Notice of Preparation of an Environmental Impact Report and Notice of Public Scoping for the Collinsville 500/230 Kilovolt Substation Project

Re: 2025010149 Collinsville 500/230 Kilovolt Substation Project, Solano, Contra Costa, Alameda, Sacramento Counties

Figure 3.5-3: Overall Recommended Alternative to Interconnect Humboldt to Fern Road and Collinsville

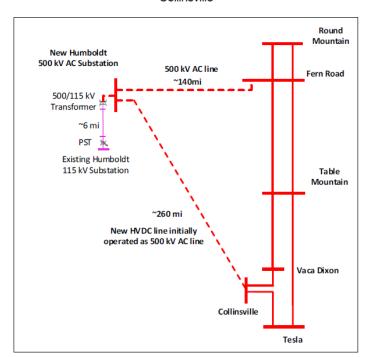
of the three qualified sponsors is "Cal Grid, LLC, an LS Power company." CAISO will soon select one of the three qualified sponsors to undertake the project. However, the Proponent's Environmental Assessment ("PEA") submitted to the CPUC concemplates none of this.

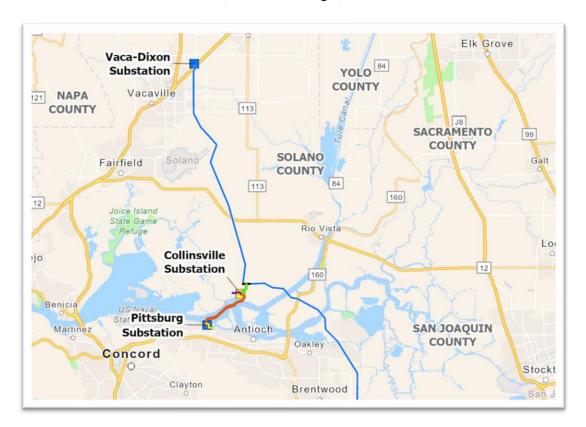
The Alternative Location includes and/or is adjacent to multiple acres of brownfield lands that previously served industrial uses which would be perfectly suited to host the substation, with far lower environmental impacts, as depicted in the aerial photo shown below.

Relocating the Substation to this location would essentially keep the proposed new Vaca-Dixon Line to Pittsburg Substation line the same (shown in green and orange in the below), but it would move the new Substation from locating it on greenfield agricultural land in Solano County (shown as yellow square on the below) to collocating it next to the Pittsburg Substation, on already disturbed brownfield industrial lands (the blue rectangle).
